**RESPONSE LETTER NO. 2 TO REQUEST FOR INFORMATION**

Project Title: **Upgrade Chiller Units at William Lehman Center**  
 Project No.: **TP-0000017889**

**UPGRADE CHILLER UNITS AT  
WILLIAM LEHMAN CENTER**

**REQUEST FOR INFORMATION NO.2**

**M-9901**  
19 of 28

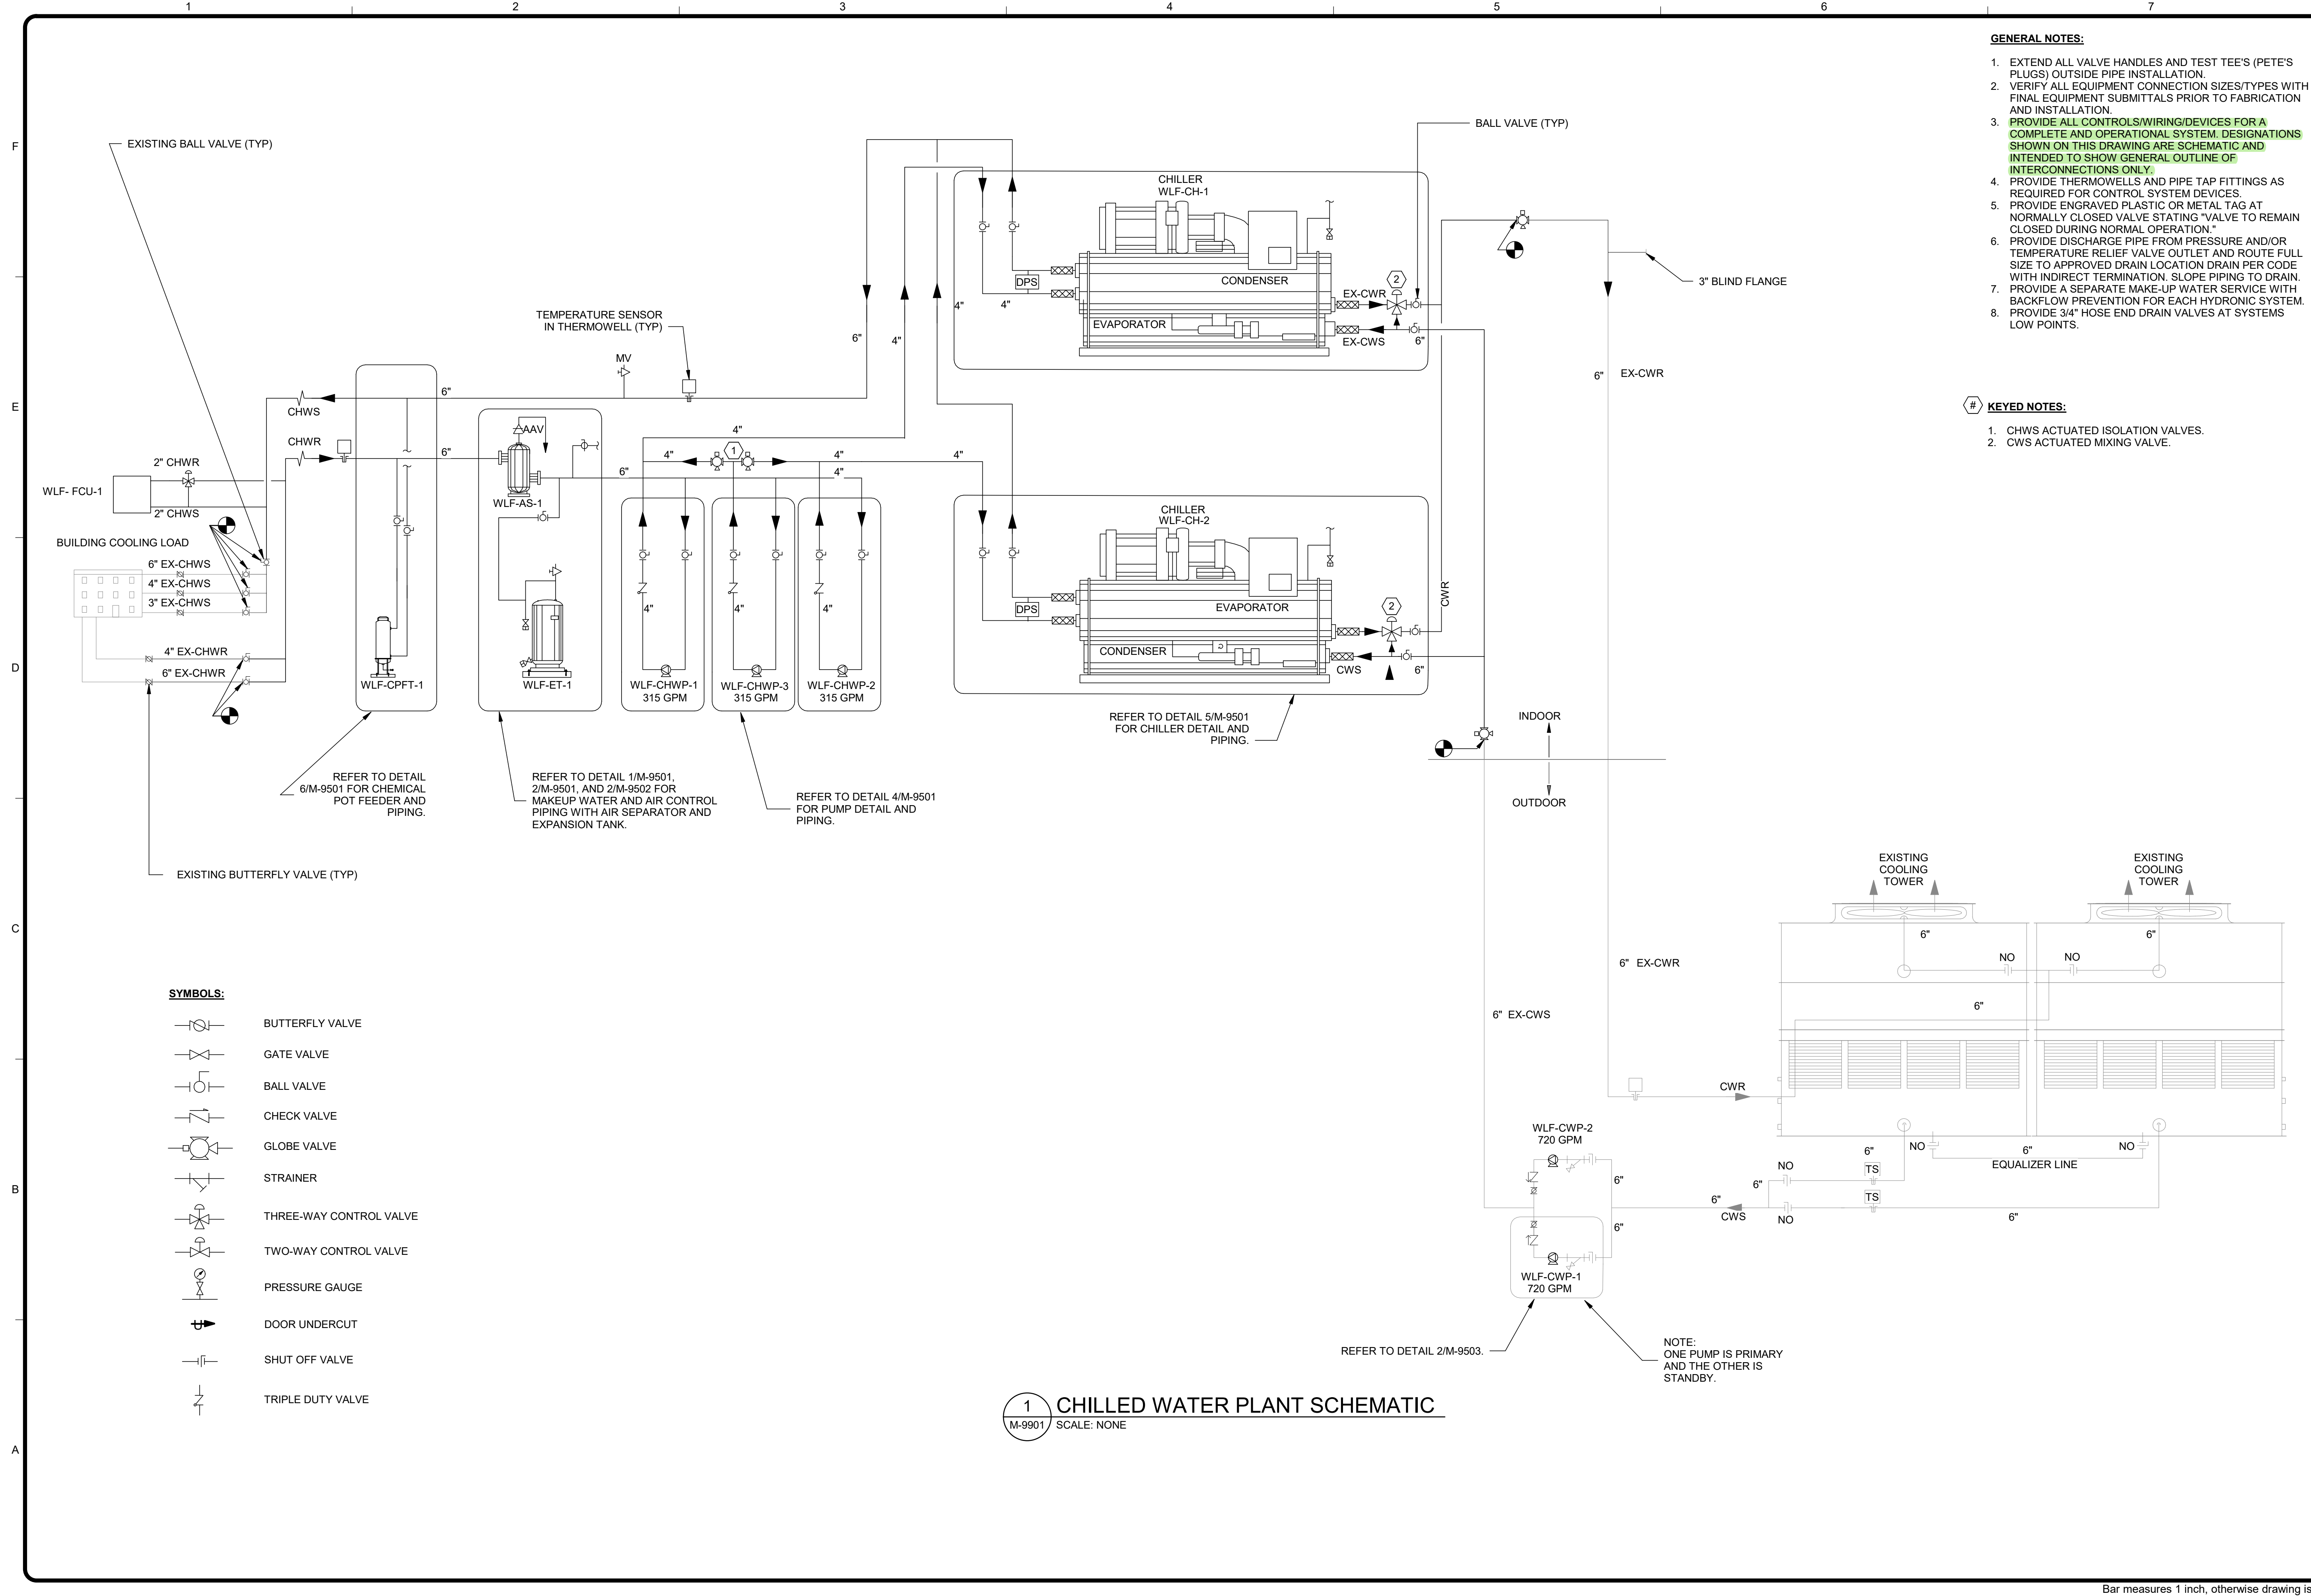
**QUESTION No.1:** Valves identified as WLF-CV-4 and WLF-CV-5:

- M9601 - Schedule calls for Model G7100D Belimo – This is a 4" Globe 3-Way Diverting Valve
- M9901 – Water Plant Schematic –
  - Keyed Note 1 – Calls them out as "CHWS ACTUATED ISOLATION VALVES"
  - Symbol used is for 4" Globe Isolation Valves that appear to be 2-Way (not 3-Way).
- M9902 – Mechanical Controls – Shows Chilled Water Isolations Valves as 2-Way in diagram.
- M9904 – Mechanical Room Perspective – Appears to show 3-Way Valve
- M3101 – Mechanical Modification Piping – Appears to show 2-Way Valve

Need to Determine if it is 2-Way or 3-Way Valves are desired, if 3-Way Valves are desired are the Mixing or Diverting?

**QUESTION No.6:** I do not see any low voltage/control wiring.  
Also control sheet that states for reference only, existing to remain.

**ANSWER No.1:** WLF-CV-4 and WLF-CV-5 are to be 2-way, manual isolation valves. Refer to revised schedule (M-9601) attached and revised Specification Section 23 05 23, Section 2.02 below. Shown on Addendum No.5.

**ANSWER No.6:** Existing to remain is in reference to existing cooling tower fan controls which are to remain as is. Refer to (1/M-9901)

**M-9902**  
20 of 28

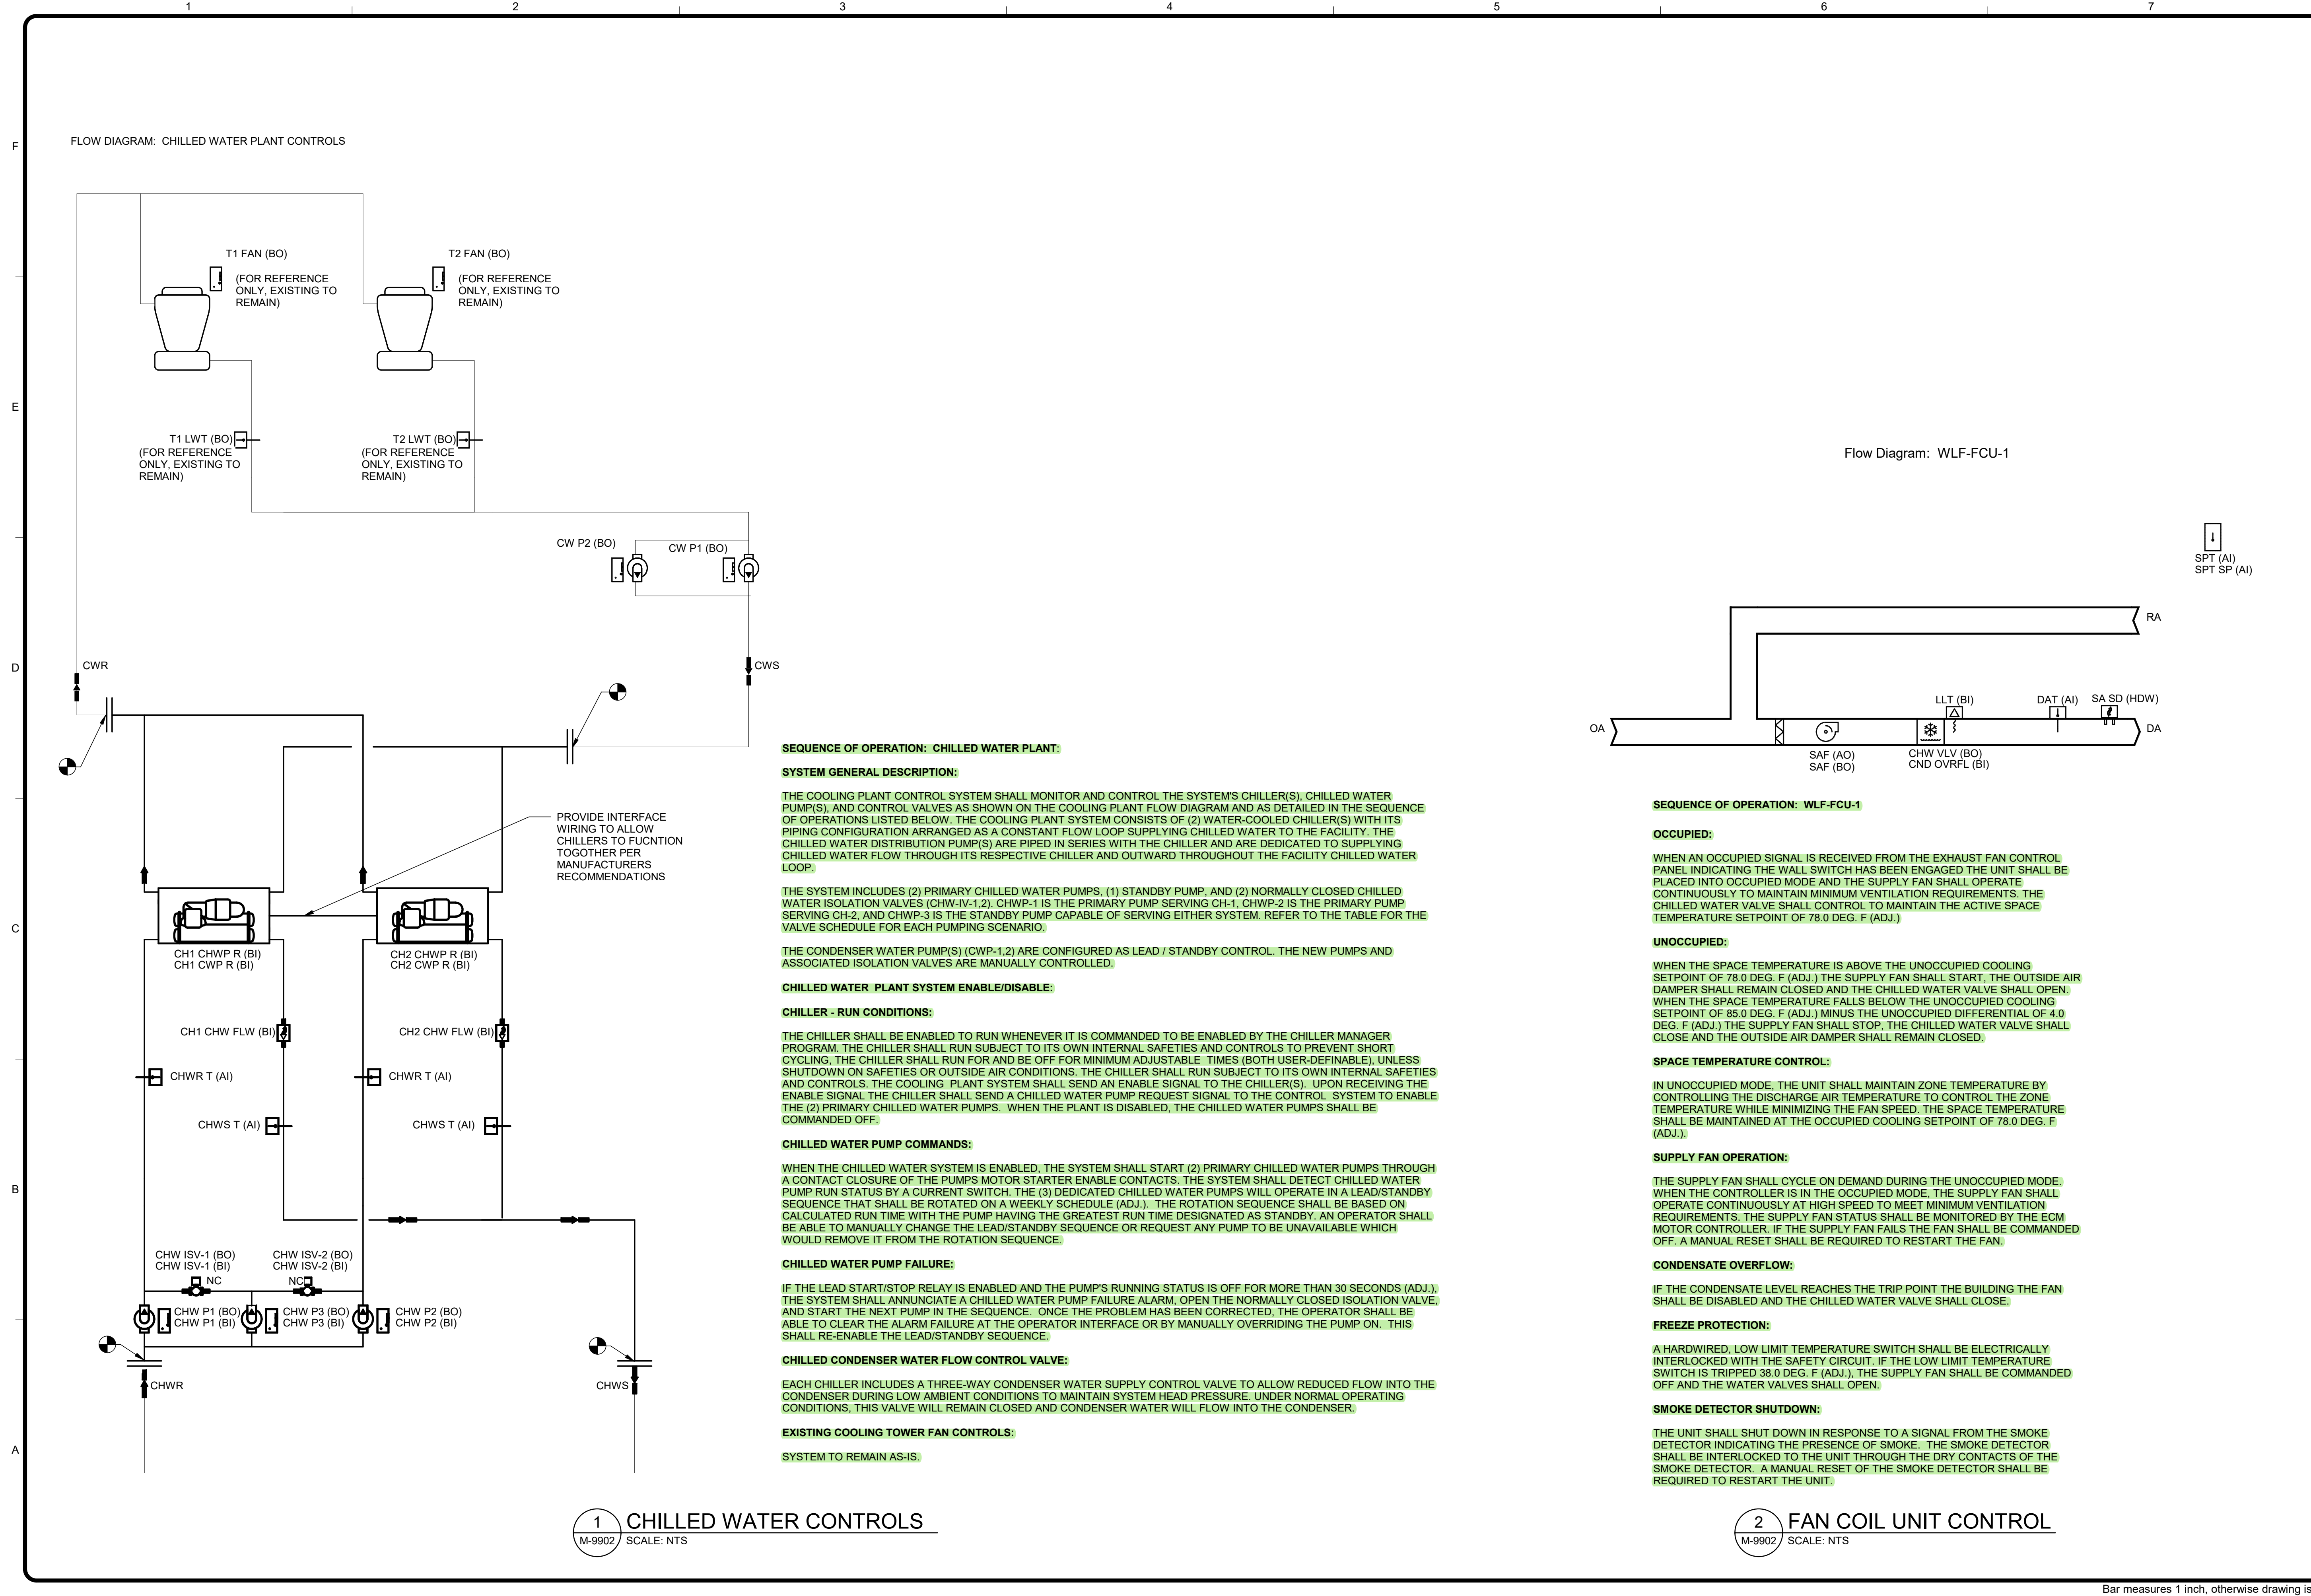
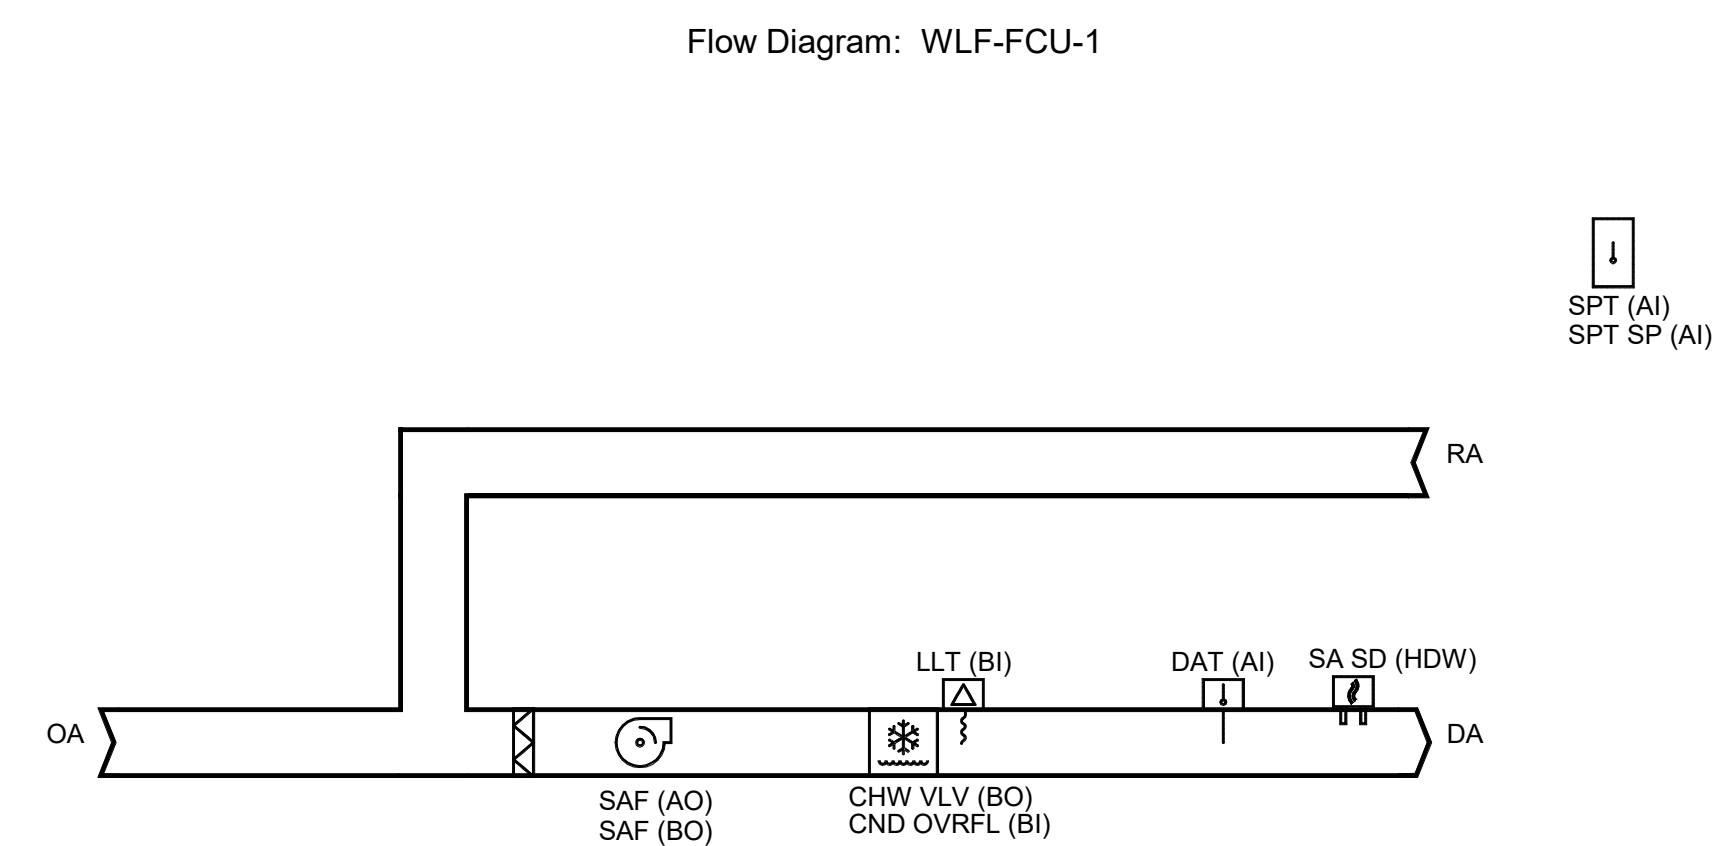
- M9601 – Schedule – Calls for Model F7100D Belimo - This is a 4" Globe
- 3-Way Diverting Valve
- M9901 – Water Plant Schematic – Shows a 3-Way Control Valve
- M9902 – Mechanical Controls –
  - Sequence Describes Controlling Discharge Air Temp (Typically Modulating)
  - FCU Schematic shows CHW VLV (BO)
- M3101 – Note 10 – 2" Valve

**QUESTION No.5:** I do not see any low voltage/control wiring.  
Yet in mechanical sheets I see (5) electrical control valves, (1) thermostat.

**ANSWER No.4:** WLF-CV-6 is 3-Way Diverting size 1.5-Inch NPT Threaded Globe Valve Model G340B-N Belimo. Refer to revised schedule (M-9601). Shown on Addendum No.5.

**ANSWER No.5:** WLF-CV-6 will be provided with modulating 24V Actuator Model SVB-24SR Belimo and shall be controlled via standalone 24V Modulating controller provided with WLF-FCU-1 including portable display mounted on wall, and integrated thermostat. Refer to revised schedule (M-9601, & M-9602). Shown on Addendum No.5.

1. Thermostat to function and control fan coil unit WLF-FCU-1 as described in the sequence of operation WLF-FCU-1. Refer to (2/M9902).
2. Fan coil unit control valve WLF-CV-6 to function via standalone 24 V controller with portable display and integrated Thermostat. Refer to Note 5 on revised M-9602 (Shown on Addendum No.5) part of additional information included with previous RFI response.
3. Chilled water condenser control valves (WLF-CV-7 & WLF-CV-8) to function as described in the sequence of operation: chilled water plant, chilled condenser water flow control valve. Refer to (1/M9902).
